THE FOLLY SUBDIVISION

FINAL PLAT COMMENTS (should be addressed prior to submitting the FINAL PLAT for review and/or signature by the City Engineer):

The plat illustrates the proposed 1-lot, 0.1± acre subdivision which is located on the East side of South Cedar Street, 125'± South of Church Street, within Council District 2. The applicant states that the subdivision is served by city water and sanitary sewer systems. The purpose of this application is to create one (1) legal lot of record from two (2) legal lots.

DETAIL SITE PLAN

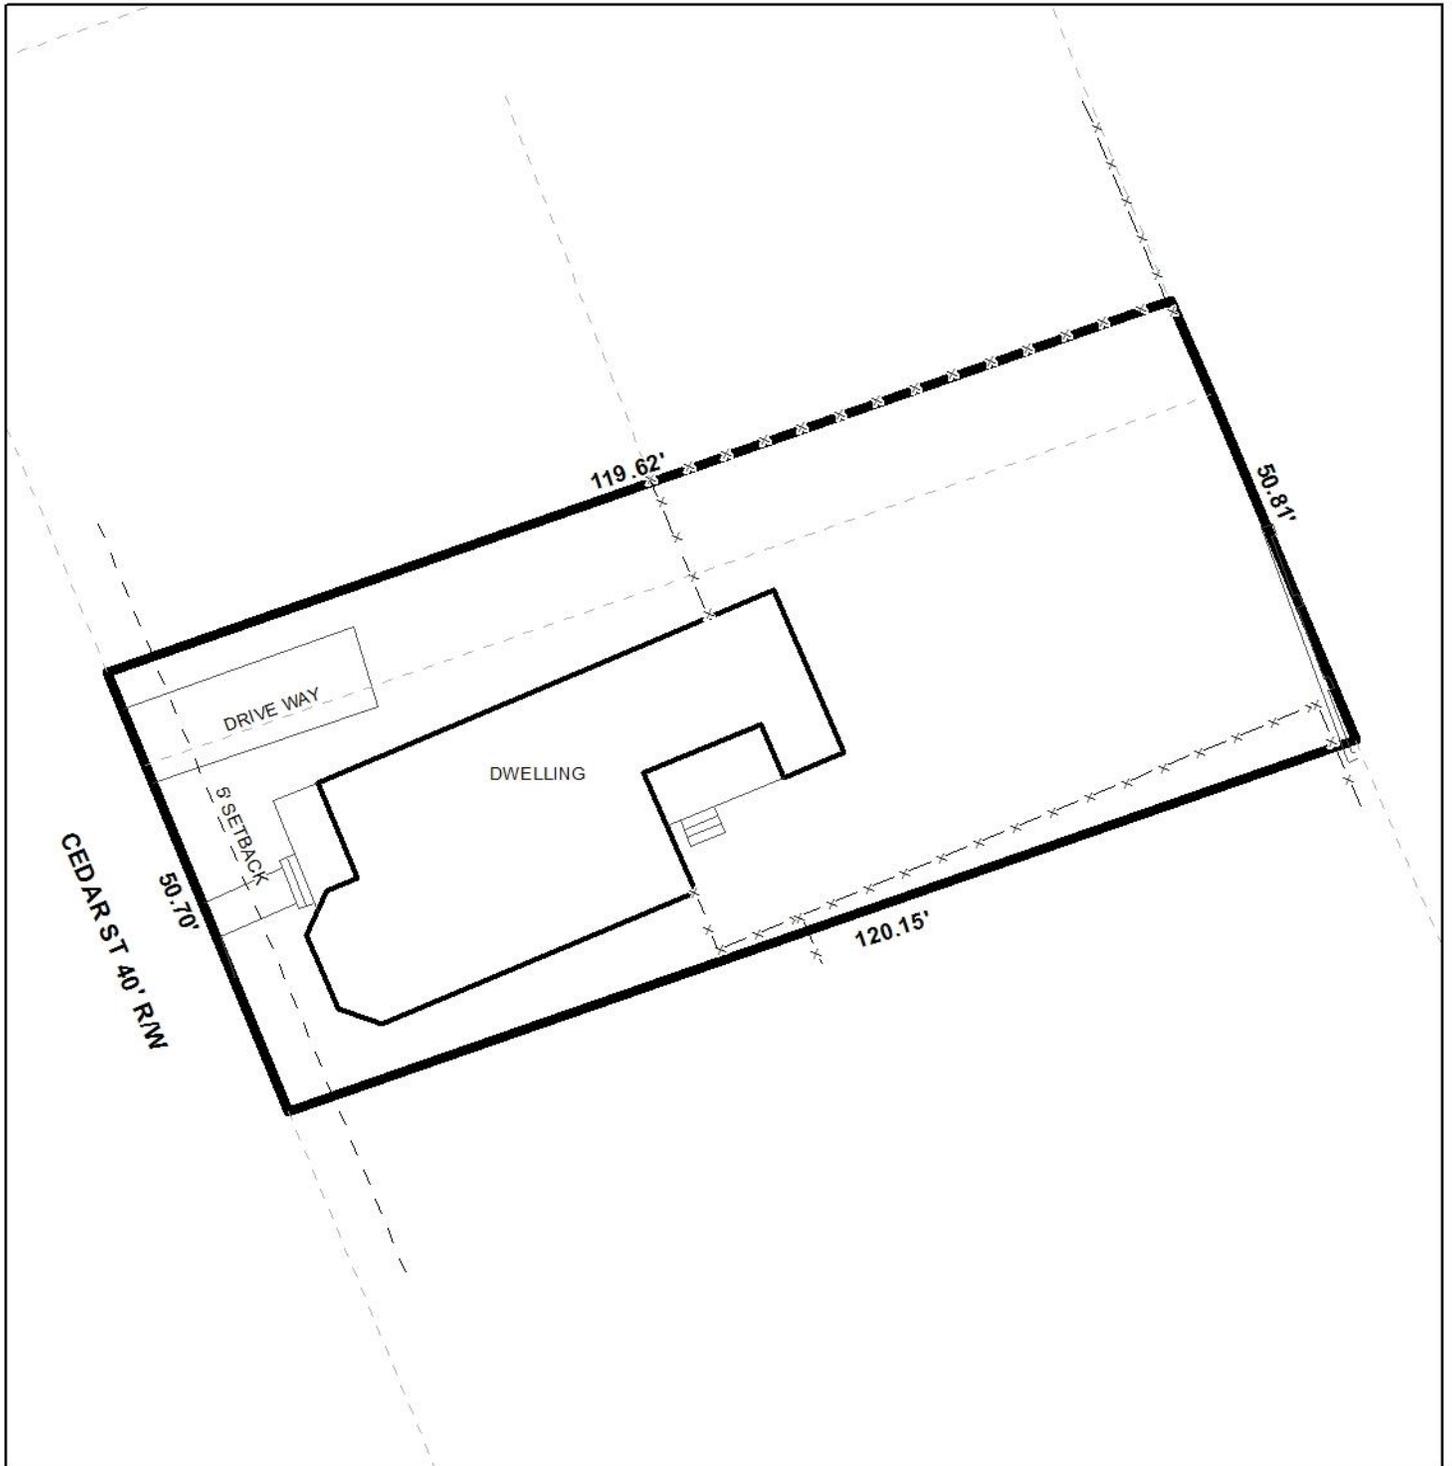
- B. Add legible street names to the vicinity map.
- C. Provide a Lot designation for the proposed LOT.
- D. Revise the plat to label each lot with its size in acres and square feet, or the furnishing of a table on the Plat providing the same information.

- E. Show and label all flood zones.
- F. Show and label the MFFE (Minimum Finished Floor Elevation) on each lot that contains an AE, V, or X (shaded) flood zone designation.

- G. Provide and label the monument set or found at each subdivision corner.
- H. Add a signature block for the Owner, Notary Public, Planning Commission, Traffic Engineer, and City Engineer.

- K. Add a note to the SUBDIVISION PLAT stating that a Land Disturbance permit will be required for any land disturbing activity in accordance with Mobile City Code, Chapter 17, Storm Water Management and Flood Control; the City of Mobile, Alabama Flood Plain Management Plan (1984); and, the Rules For Erosion and Sedimentation Control and Storm Water Runoff Control.

- L. Add a note to the Plat stating that the approval of all applicable federal, state, and local agencies (including all storm water runoff, wetland and floodplain requirements) will be required prior to the issuance of a Land Disturbance permit.

- M. Add a note that sidewalk is required to be constructed, and/or repaired, along the frontage of each lot, or parcel, at time of new development or construction, unless a sidewalk waiver is approved.

Traffic Engineering Comments: Lot is limited to one curb cut to South Cedar Street with size, location and design to be approved by Traffic Engineering and conform to AASHTO standards.

The proposed subdivision fronts South Cedar Street, a minor street. The preliminary plat illustrates a 40' right-of-way width for South Cedar Street. All abutting streets are "B" streets, according to the Downtown Development District (DDD) Regulating Plan Street Hierarchy.

Section 64.3.I.8.(d) of the DDD ordinance requires a minimum setback of 10' and a maximum setback of 18' for the primary frontage in T-3 Sub-Districts. A minimum 10' side yard and 20' rear yard setback is also required. Properties located within T-3 sub-districts are required to have 40' minimum property width and a 120' maximum width. The proposed lot meets the property width requirements. If approved, the required setbacks should either be illustrated, or notes stating the same should be placed on the Final Plat.

The DDD requires a parking setback equal to the setback of the front façade for T-3 Sub-districts per Section 64-3.I.8.(d) of the DDD code. If approved, a note should be placed on the Final Plat indicating that a parking setback shall be equal to the setback of the front façade.

The proposed lot does not appear to meet the 7,200 square foot minimum lot size requirements of Section V.D.2. of the Subdivision Regulations for lots served by public water and sanitary sewer systems. However, there is no minimum lot area requirement for lots within the DDD, making a waiver of Section V.D.2. of the Subdivision Regulations appropriate. The preliminary plat does not provide the lot size in square feet or acres. If approved, the lot size information should be provided in both square feet and acres on the Final Plat.

As a means of access management, the Traffic Engineering comments should be placed on the Final Plat, if approved; stating that the proposed Lot is limited to one curb cut to South Cedar Street with size, location and design to be approved by Traffic Engineering and conform to AASHTO standards.

- 1) Retention of the 40' right-of-way width for South Cedar Street;
- 2) Illustration of 10' minimum building setback and 18' maximum building setback line along Cedar Street or placement of a note stating the required 10' minimum and 18' maximum setbacks;
- 3) Provision of lot size information in both square feet and acres;
- 4) Placement of a note stating that the parking setback shall be equal to the setback of the front façade;

- 5) Placement of a note on the Final Plat stating that the Lot is limited to one curb cut to South Cedar Street with size, location and design to be approved by Traffic Engineering and conform to AASHTO standards.
